Swedish Radiation Safety Authority

Technical Note

2012:24

Initial Review of SR-Site
Main Report

Figure 2.1: Outline of the eleven main steps of the SR-Site safety assessment. The boxes at the top above the dashed line are inputs to the assessment (SKB 2011, TR-11-01, page 66).

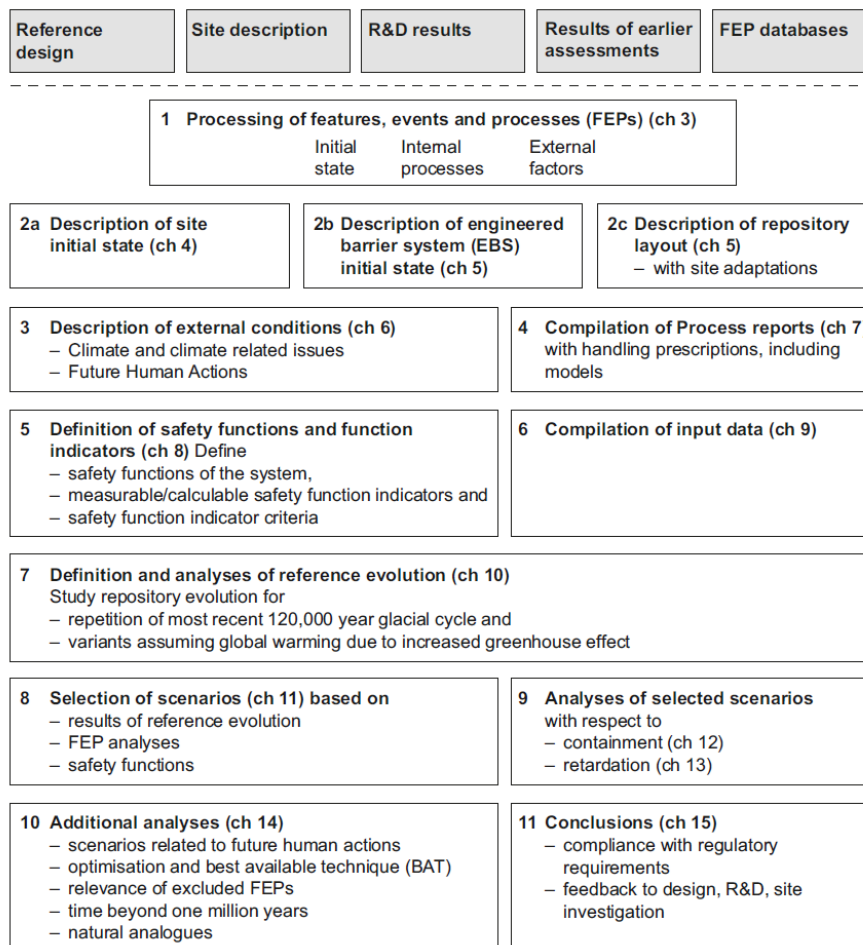
More specific observations on SKB's assessment methodology include:

- SKB's assessment approach (see SKB 2011, TR-11-01 Figures S-7 and 2-2) does not emphasise the important steps of conceptual model development and model documentation. Models of processes are mentioned in Step 4 '*Compilation of process reports*' (see Figure 2.1) and in SKB 2011, TR-11-01, Section 2.5.4 '*Description of processes*', but examination of the Process reports reveals that the '*Handling in the safety assessment SR-Site*' sections they contain often refer to yet further reports at lower levels in SKB's documentation scheme. For example, the Buffer, backfill and closure process report (SKB 2010, TR-10-47) refers to an underlying report by Åkesson *et al.* (2010a, b) for details of buffer homogenisation modelling. This observation is not necessarily a criticism of SKB's work, but coupled with the fact that many processes and FEPs are modelled, it does suggest that reviewing and assessing SKB's modelling work for SR-Site is likely to be a significant review task involving examination of several layers of documentation. Section 2.4 below provides suggestions regarding priorities for detailed review of key areas.
